## UNITED STATES ENVIRONMENTAL PROTECTION AGENCY

March 15, 2004

Conditional Approval of General Electric's Work Plan Phase 3 Floodplain Properties, Group 3A, 3B, 3C, and 3D, 8 January 2004, General Electric/Housatonic River Project Site,

Group 3A. Refer to Figure 2 (Attached).

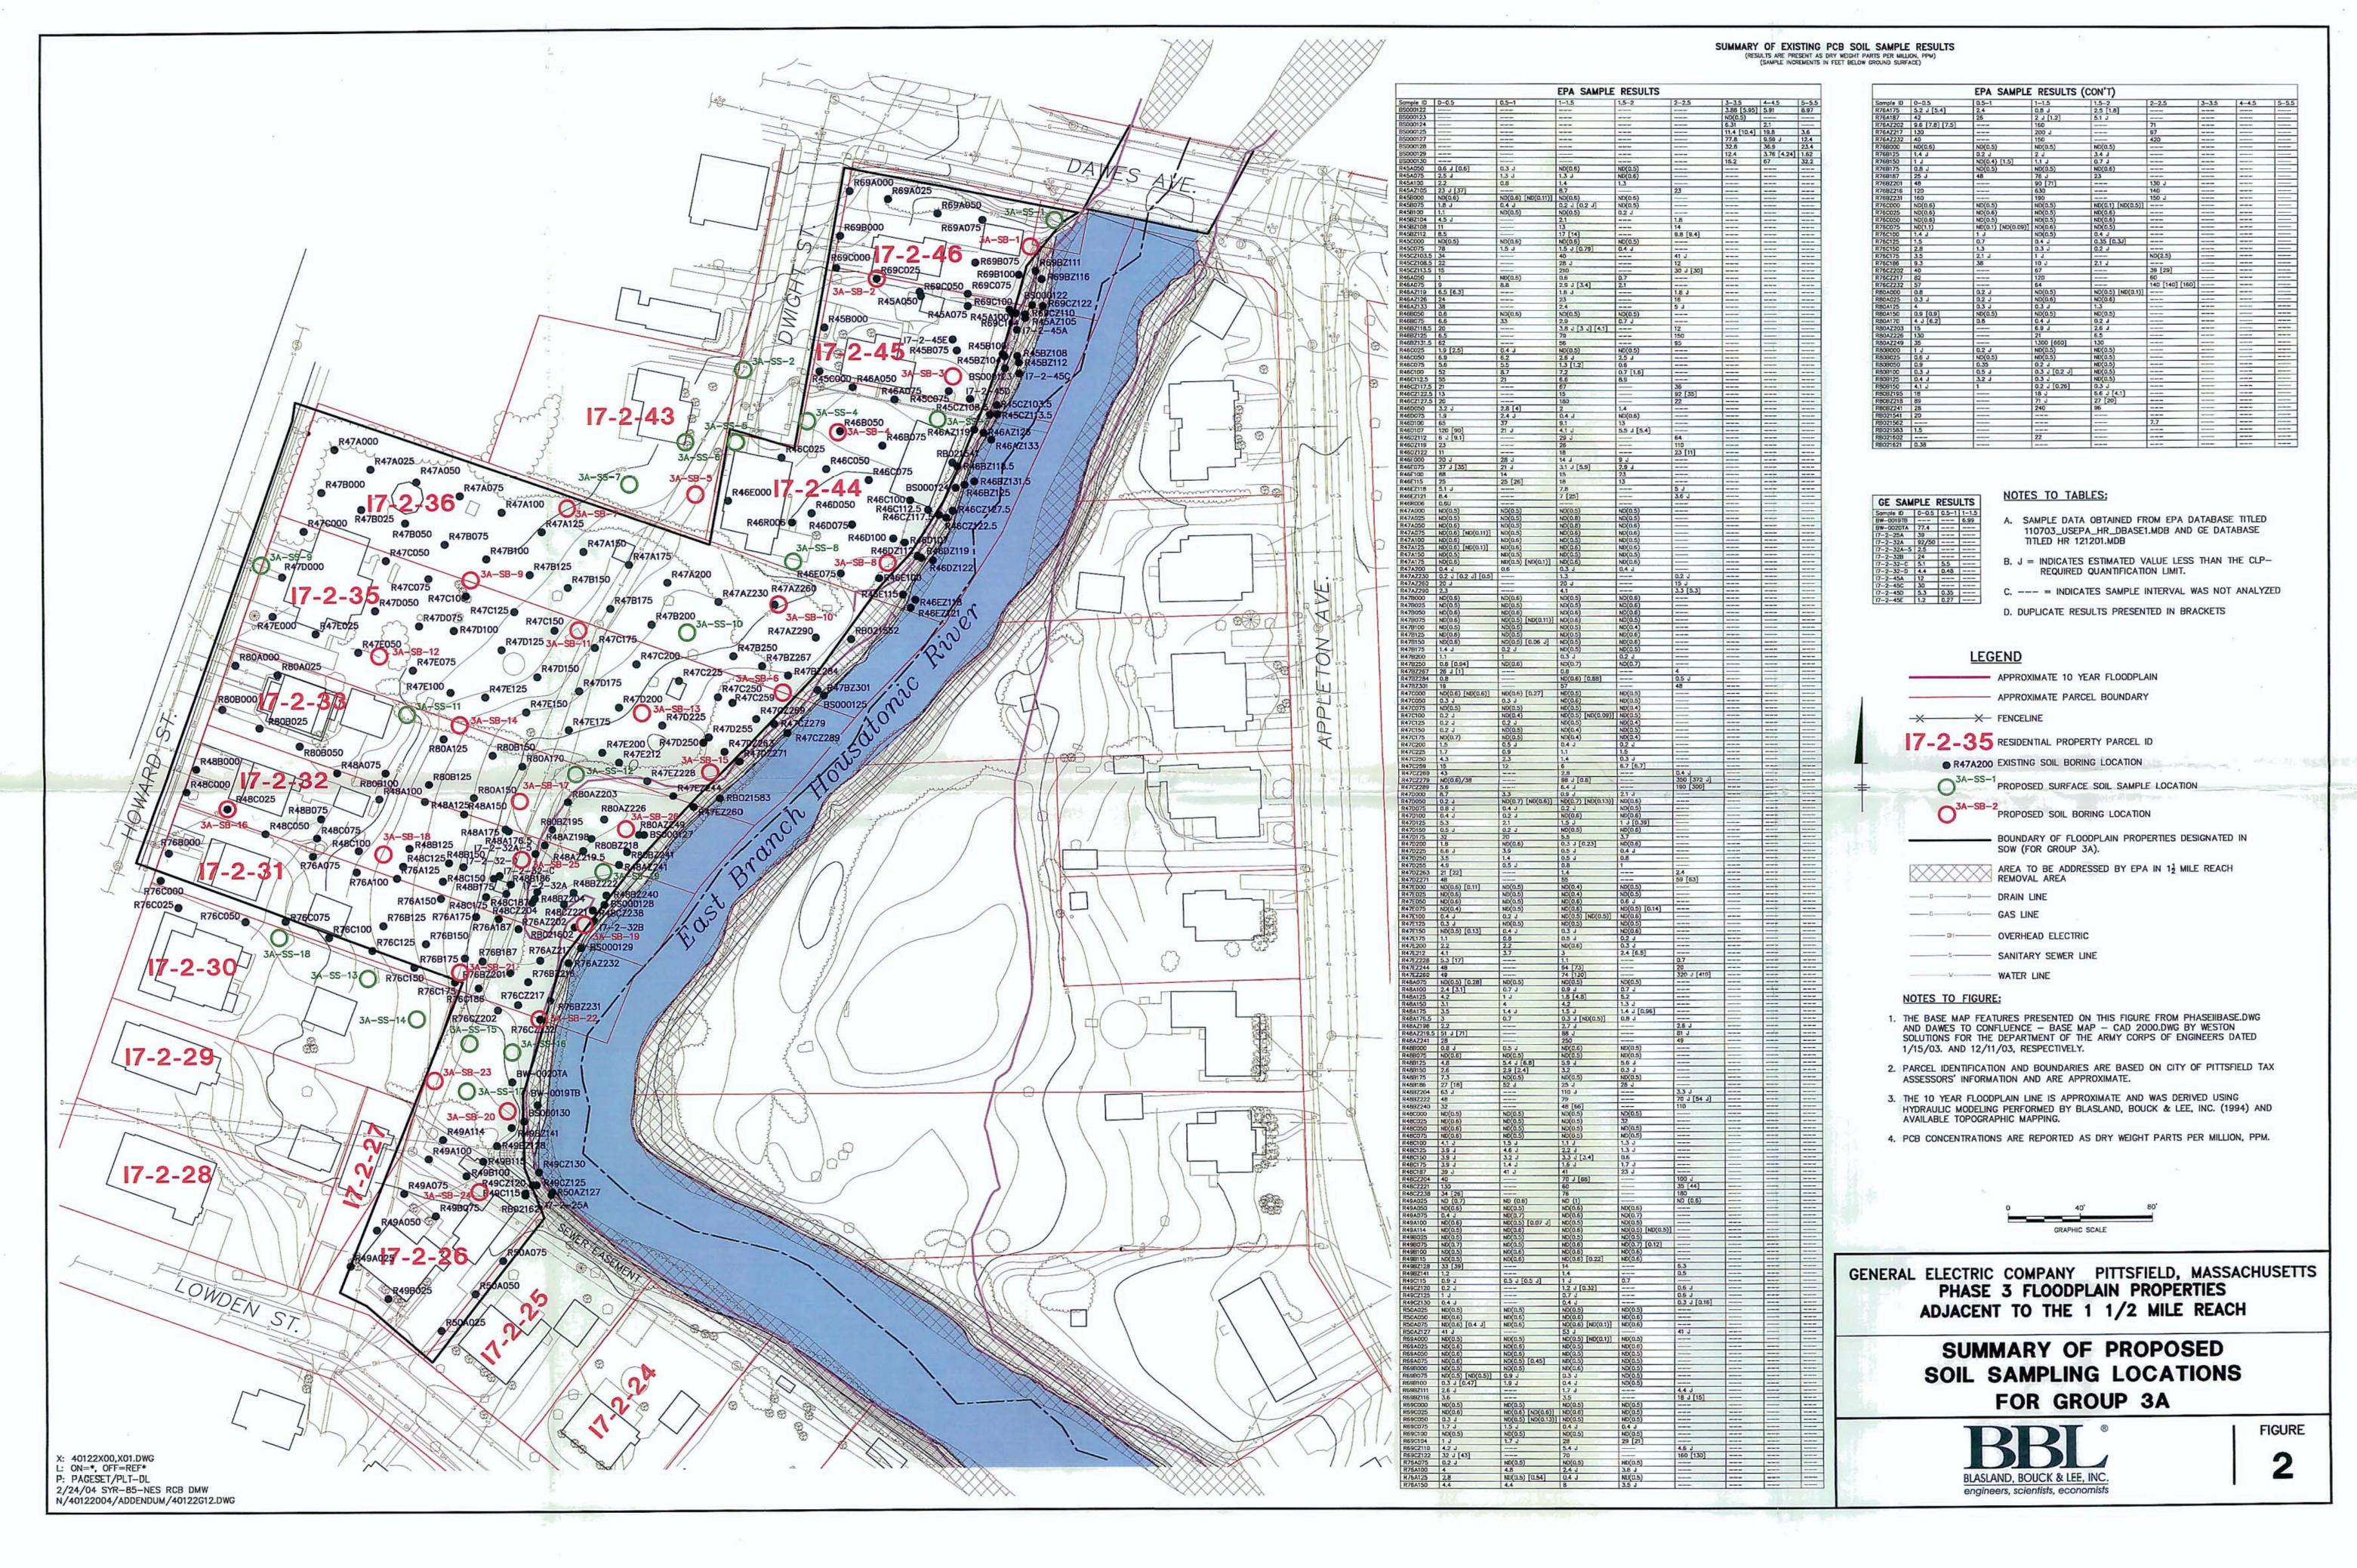
## Lot 17-2-26

- 1. Replace surface sample 3A-SS-18 with boring 3A-SB-20 (from Lot I7-2-30).
- 2. Replace boring 3A-SB-20 with surface sample 3A-SS-18.
- 3. Move 3A-SS-15 and 3A-SS-16 to the east approximately 15ft closer to the 10-year floodplain.

### Lot 17-2-32

- 1. Move proposed boring location 3A-SB-19 slightly to the southeast to fall within the 10-year floodplain.
- 2. Add a new boring, 3A-SB-25, in the approximate center of the following previous sample locations: I7-2-32A-5; I7-2-32-C; and I7-2-32A.

3. Add a surface soil sampling location, 3A-SS-19, approximately 30 feet north of existing sampling location RB021602.

#### Lot 17-2-33

1. Add a new boring, 3A-SB-26, in the approximate center of the following previous sample locations: BS000127; R80AZ249; and R80AZ226.

### Lot 17-2-35

1. Move proposed boring, 3A-SB-6, to the approximate center of the following previous sampling locations: R47CZ269 and R47BZ284.

### Lot 17-2-46

1. Move location 3A-SB-1 to the southeast to a location behind the garage.

Group 3B. Refer to Figure 3 (Attached).

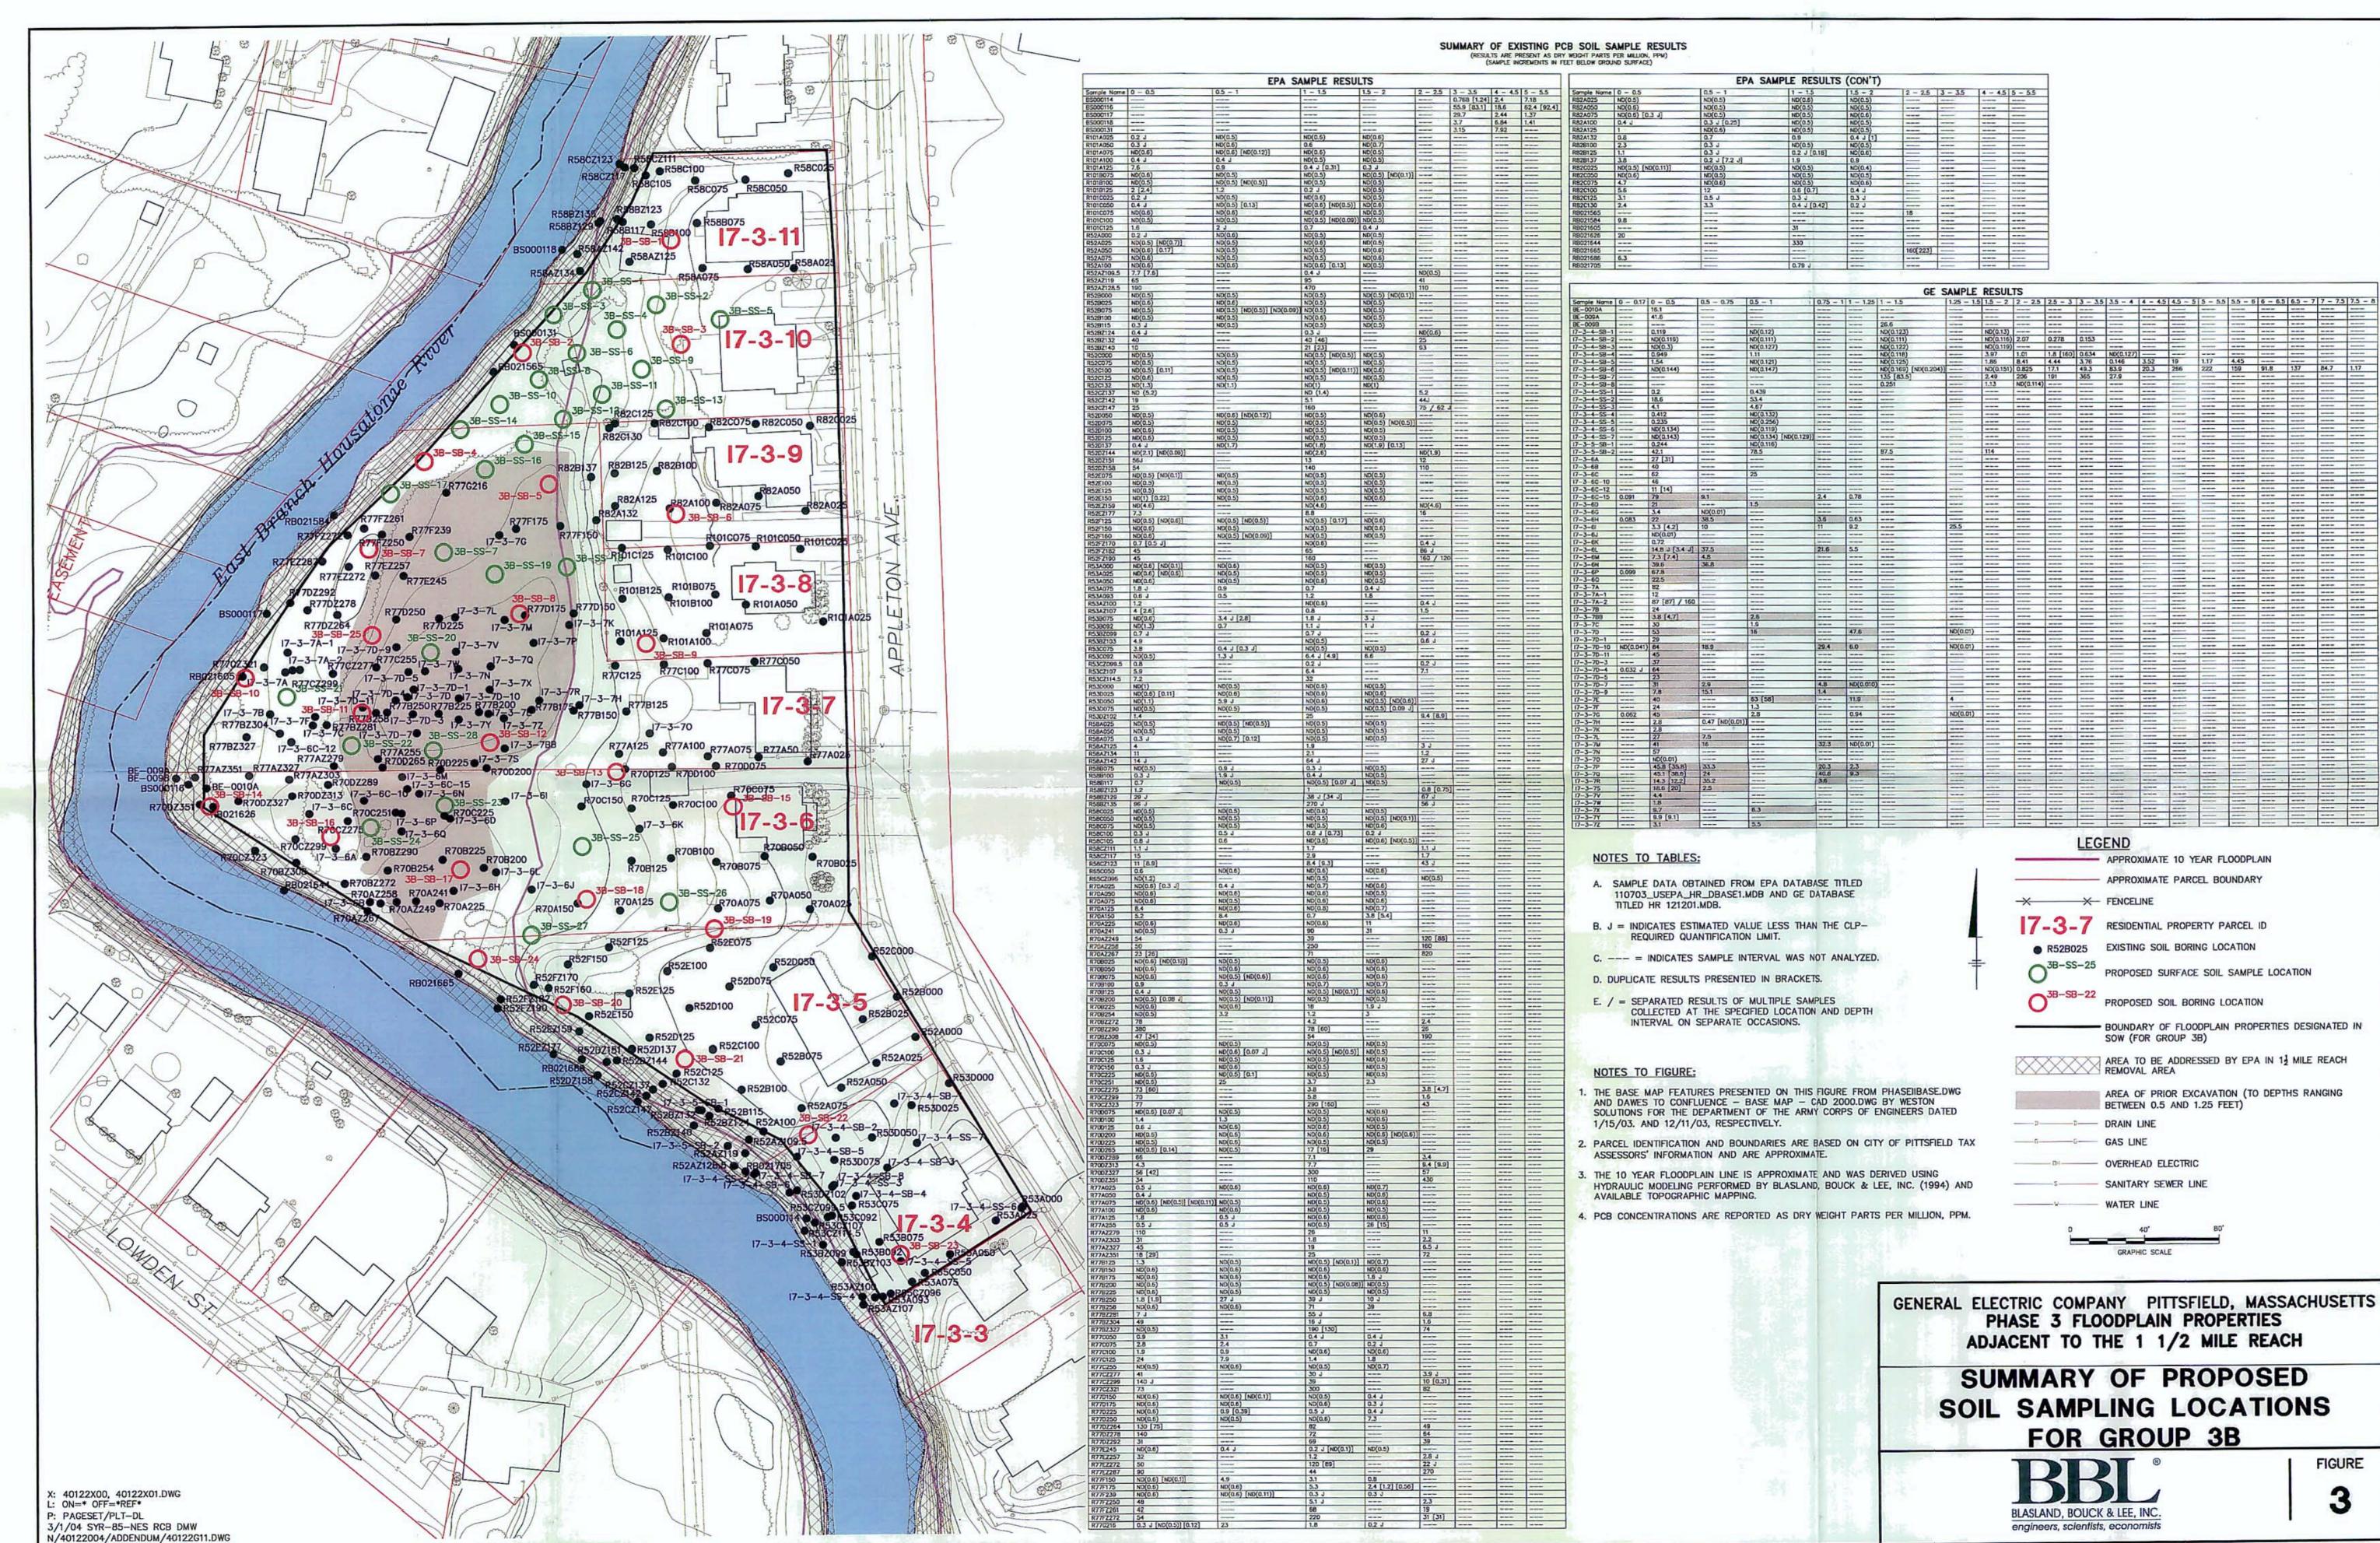
## Lot 17-3-5

- 1. Move proposed boring 3B-SB-22 approximately 25ft south to property line between 17-3-4 and 17-3-5.
- 2. Add a new boring, 3B-SB-24, approximately 15ft northeast of RB021665.

## Lot 17-3-7

- 1. Move boring 3B-SB-7 approximately 20ft northwest to the approximate center of the following previous sample locations: R77FZ261; R77FZ250; R77EZ272; and R77EZ257.
- 2. Replace surface sample 3B-SS-20 with a new soil boring, 3B-SB-25, to provide spatial coverage in the vicinity of existing sampling location R77DZ278.
- 3. To provide better spatial coverage across the area where an STM was performed, add surface soil sampling locations as follows:
  - 3B-SS-20, approximately centered between existing locations I7-3-7D-9 and I7-3-7V;
  - 3B-SS-7, approximately centered between existing locations R77F239 and 3B-SS-19; and,
  - 3B-SS-28, approximately centered between existing locations I7-3-7D-7 and R70D225.

### Lot 17-3-10

- 1. Replace boring 3B-SB-2 with surface sample 3B-SS-6.
- 2. Replace surface sample 3B-SS-6 with boring 3B-SB-2.
- 3. Move boring 3B-SB-3 approximately 20ft northwest to location 3B-SB-7.
- 4. Move surface sample 3B-SS-7 to approximately center of R77F239 and 3B-SS-19 as described above for Lot 17-3-7.
